JOHN NULTY LTD.

Non-Technical Summary

Environmental Impact Assessment Report

REVISION FOR ACP

Figure 2.4 Proposed Site Layout Plan

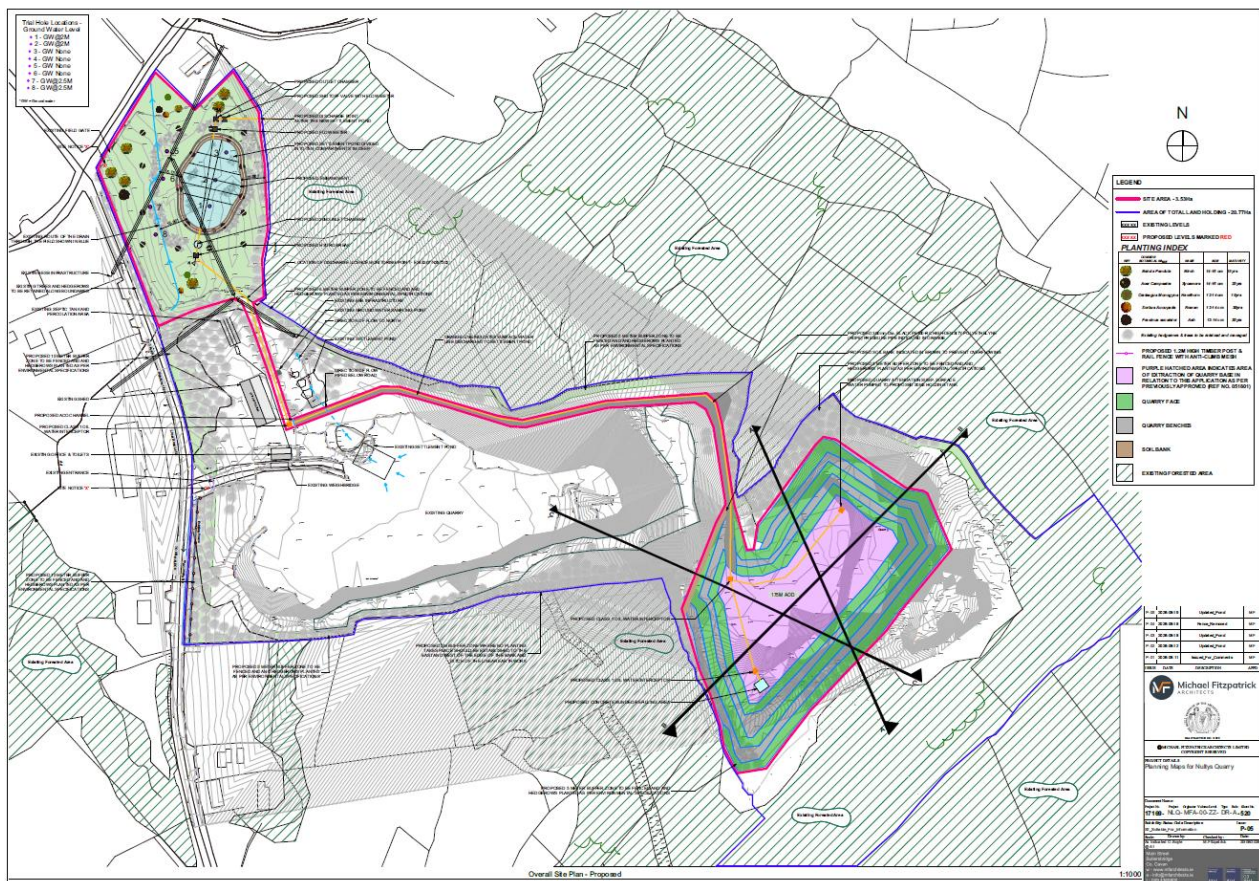
Works will also include the provision of a new settlement pond and associated surface water drainage, attenuation and treatment infrastructure, including a quarry-floor attenuation sump, pumped transfer system, 20 m³ holding/inlet arrangement, Class 1 oil-water interceptors, ACO channel, Hydro-Brake flow-control arrangement, in-line flow meter, shut-off valve and proposed additional discharge point. Ancillary site works will include landscape works, planting, restoration of the quarry perimeter and reprofiling of overburden as required to facilitate development of the quarry and restoration of the associated site area.

- Surface water generated within the proposed development catchment will be managed through a dedicated surface water drainage, attenuation and treatment system. The system will incorporate a quarry-floor attenuation sump, pumped transfer system, 20 m³ holding/inlet arrangement, Class 1 oil-water interceptors, ACO channel, an impermeably lined ten-compartment settlement and attenuation pond, Hydro-Brake flow-control arrangement, in-line flow meter and shut-off valve.

- Discharge from the proposed system will be restricted by the Hydro-Brake to a maximum rate of 24.204 L/s and will discharge through the proposed additional discharge point to the existing surface water drainage network, which ultimately drains to the Ballinagh Stream.

- The existing QY7 drainage system will remain hydraulically separate from the proposed development drainage system. The existing QY7 settlement ponds will continue to serve the existing quarry and discharge through the existing licensed

- The proposed settlement pond will be located to the north of the existing site office on lands within the ownership of John Nulty Ltd. The existing and proposed drainage arrangements are shown on Drawing No. 17169-NLQ-MFA-00-ZZ-DR-A-520 – Proposed Site Layout.
- Ancillary works will include landscape works, planting, restoration of the quarry perimeter and reprofiling of overburden as required to facilitate development and subsequent restoration of the site.

The final surface water management arrangement is shown on Drawing No. 17169-NLQ-MFA-00-ZZ-DR-A-520 – Proposed Site Layout.
